**CULTURAL RESOURCES OFFICE  
PRESERVATION BOARD  
REGULAR MEETING  
MONDAY JUNE 24, 2013 — 4:00 P.M.  
1520 MARKET ST. #2000  
[www.stlouis-mo.gov/cultural-resources](http://www.stlouis-mo.gov/cultural-resources)**

DATE: June 24, 2013  
ADDRESS: 2856 Salena Street  
ITEM: Preliminary Review to install new front door and entryway.  
JURISDICTION: Benton Park Certified Local Historic District — Ward 9  
STAFF: Bob Bettis, Cultural Resources Office

DATE: June 24, 2013  
ADDRESS: 2720-22 South Jefferson Avenue  
ITEM: Preliminary Review to install 10 windows on the front façade in response to the denial of recent application to retain non-compliant windows.  
JURISDICTION: Benton Park Certified Local Historic District — Ward 9  
STAFF: Bob Bettis, Cultural Resources Office

**PROPOSED ENTRY**

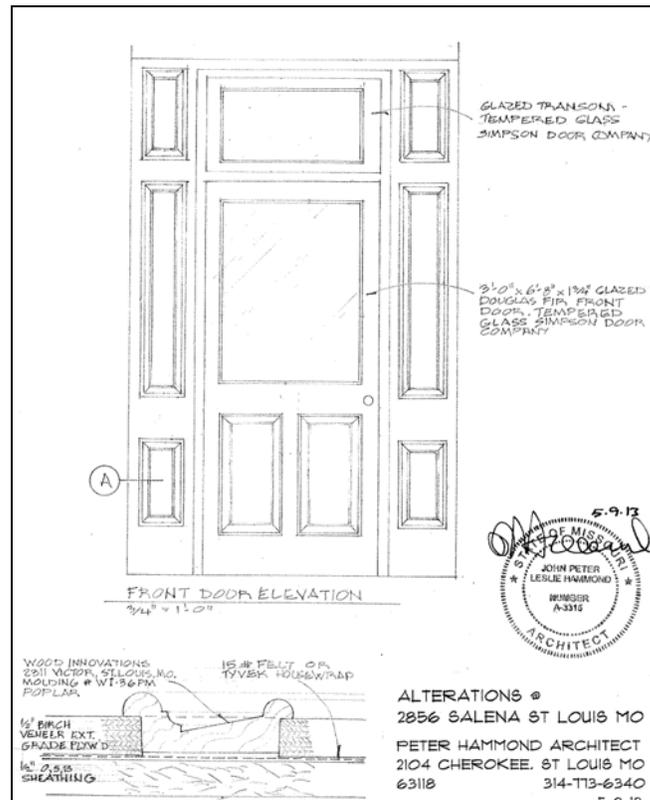
Does not comply as the proposed entry does not replicate the original condition or a Model Example. The original entry consisted of two angled doors as shown by evidence on the interior and given the width of the exterior opening. At some point the entry was modified to incorporate a single centered door that does not meet the current district standards. The proposed alteration is for a single door with flanking side panels. The proposed door, which has already been purchased, does not match the original panel configurations which are still extant on the reveals of the recessed entry.

- 2856 Salena is located in the Benton Park Local Historic District.
- The entry’s original configuration had two angled doors.
- The entry of the building was reconfigured from paired doors to a single door yet some of the original design remains on the sides of the entrance.
- The proposed entryway is not based on an acceptable Model Example. The applicant has submitted examples of paired entries that are wider and have doors that are parallel to the façade as opposed to being placed in an angled position.
- The purchased door does not match the configuration of the existing historic paneling, as was the historic condition.

Based on the preliminary findings, the Cultural Resources Office recommends that the Preservation Board deny the Preliminary Application to replace the entry as it does not comply with the Benton Park Historic District Standards. The Office recommends that the applicant use a Model Example with two angled doors to recreate the historic condition or install a new door and surround that replicates the paneling and proportions of the existing historic material in the entrance.

**PHOTO SHOWING ORIGINAL SEGMENTAL ARCHED BRICKMOLD EYEBROWS ADDED LATER TO INCORPORATE STORMS**

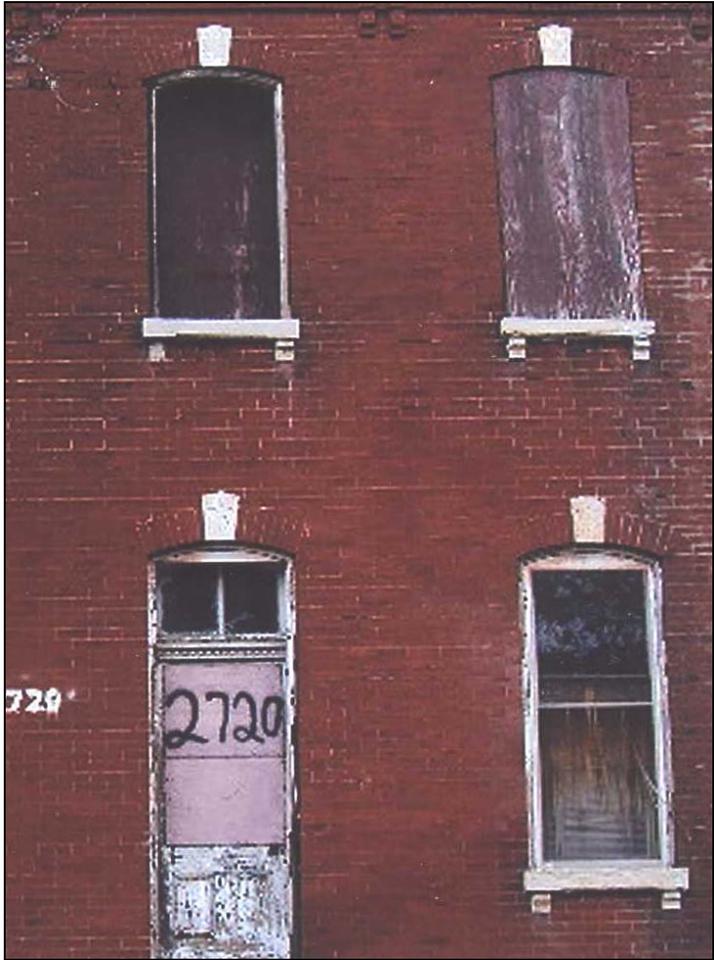
The proposed windows on the public façade do not comply with the Benton Park standards. The original windows, removed and replaced without a permit, had segmental arches. The owners propose to replace them with flat-headed windows, although the proposal would utilize windows from our approved list of replacement windows. The remaining three facades would retain their non-compliant windows.

- 2720-22 S. Jefferson is located in the Benton Park Local Historic District.
- The existing windows were installed without an approved permit.
- The owner proposes to remove the existing windows on the front façade and replace them with approved historic replacement windows, remove the metal wrap and install a compliant brickmold. In these ways the windows would be an improvement over the existing sash.
- The proposed window sash does not replicate the original as they have flat heads rather than the segmental arches of the original windows.
- The front façade was recently rebuilt and the openings framed in a manner that will not allow for arched windows to be installed without reframing. The reconstruction of the façade was also done without an approved permit.
- The non-compliant windows on the side and rear facades would not be replaced.

Based on the preliminary findings, the Cultural Resources Office recommends that the Preservation Board deny the new Preliminary Application to install flat-headed windows as they would not comply with the Benton Park Local Historic District Standards.

The goal for this property now is to minimize the reduction of the historic appearance of the building caused by the existing windows. Two ways to move forward merit consideration: Replace the front façade sash with arched units so that the façade is compliant. Or, replace the non-compliant sash on all three visible sides of the building as an alternative to reframing the arched openings of the front windows. The Cultural Resources Office recommends consideration of these two alternatives rather than the owners' proposal as the appropriate means to mitigate the violation.
